CITY OF PORTLAND, MAINE

Department of Building Inspection

AP - Cliff Island  
(Assessors Lot No. 109F-A-1)

Subject: Inquiry in regard to framing of proposed  
water tank and washroom attached to cottage on  
Church Avenue, Cliff-Island

Tank House for  
 David C. Coyle CE.  
 Cliff Island Me

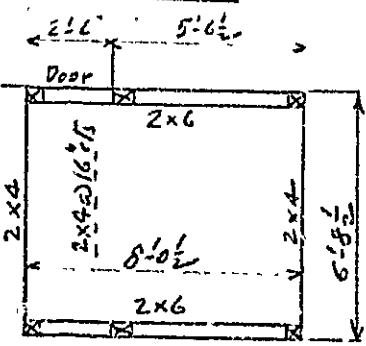
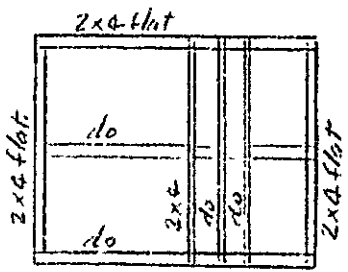
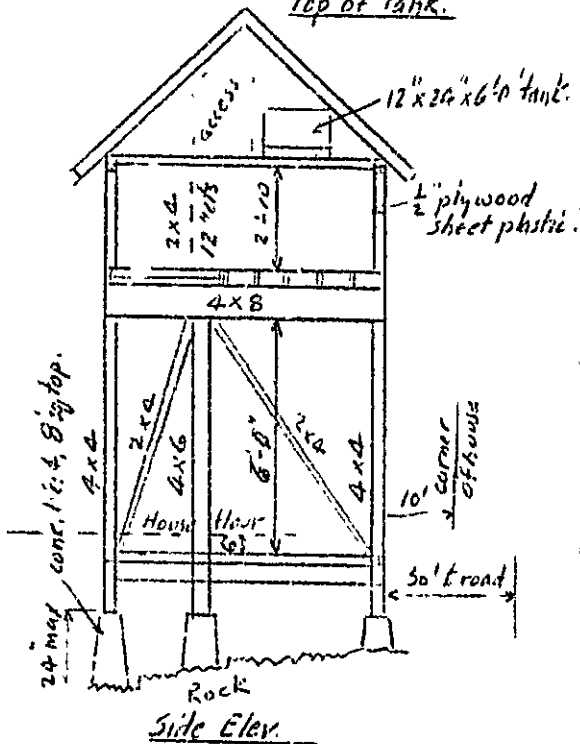
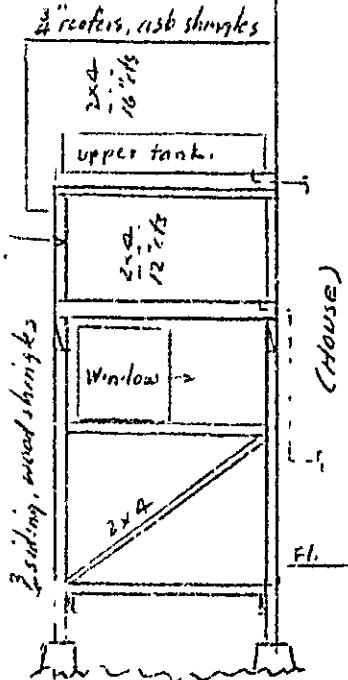
We regret our delay in answering your inquiry concerning the proposed water tank and washroom to be attached to your cottage on Church Avenue at Cliff Island, but the pressure of other business has prevented us from doing so until this time. There are some details about the proposal which we do not clearly understand and which have considerable bearing upon the type of construction allowable for the work.

If the washroom space beneath the tank is to be left open, then the construction shown would appear to meet requirements. However should you plan to enclose the entire structure as a part of the cottage, then the rules regarding the construction of buildings would apply. In the latter case sills of no less than 4x6, all one piece in cross section, would be required on top of the piers with the floor timbers and studs supported on them. The posts at the corner would need to be no less than 4x6, either one piece in cross section or built up of 2x4's, extending in one length from sill to plate at top of tank where roof is to be supported. At least 2x4 studs would be required in the walls, but these may be spaced 24" on centers instead of the usual 16" on centers if the building to which the addition is to be attached is a cottage built for summer use only.

Please let me know what modifications  
in these plans are necessary to comply with  
the code.

When you get ready to do the work, which we presume will not be until next spring or summer, you should make application at this office for a permit covering the work. If this is to be an open structure, the plan which you have sent in for criticism, one copy of which we are keeping for our files, may be filed with the application. If the structure is to be built as an enclosed part of the cottage, you should revise your plan to show compliance with Building Code requirements for such an addition and file a copy of the revised plan with your application. We are returning the original of your plan with this letter.
